Planning Commission

Meeting Minutes

March 21, 2016

FDP-112-2015 Final Development Plan

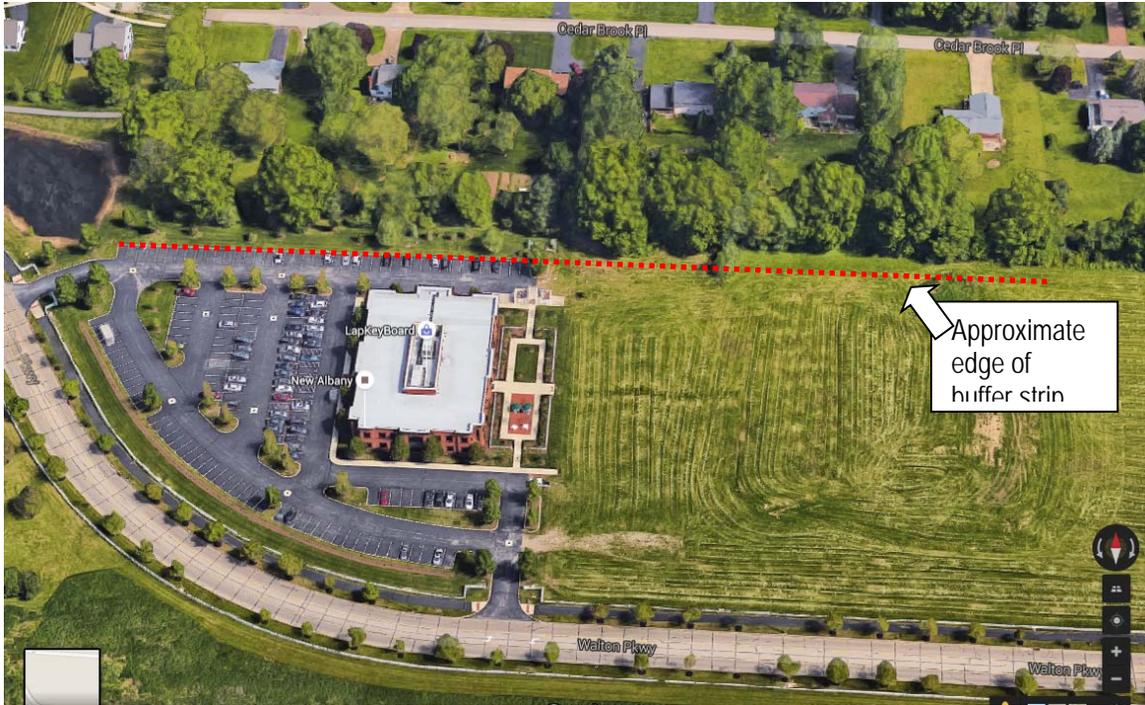
3. The variance does not appear to be substantial and preserves the "spirit and intent" of the zoning requirement since the likely objective of the requirement is to screen cars and their headlights. City code requires a minimum height of four feet of landscaping, mounding, or walls to screen vehicles from streets and neighboring properties. The four foot tall mound appears to adequately screen vehicle headlights from Cedar Brook residences.

4. It does not appear that the variance would adversely affect the delivery of government services, affect the health and safety of persons residing or working in the vicinity of the proposed development, be materially detrimental to the public welfare, or injurious to private property or public improvements in the vicinity.

In summary, staff supports this variance request for a reduction in the minimum mounding height from five feet to four feet. The variance preserves the "spirit and intent" of the zoning requirement since the likely objective of the requirement is to screen cars and their headlights. For this reason the request does not seem substantial.
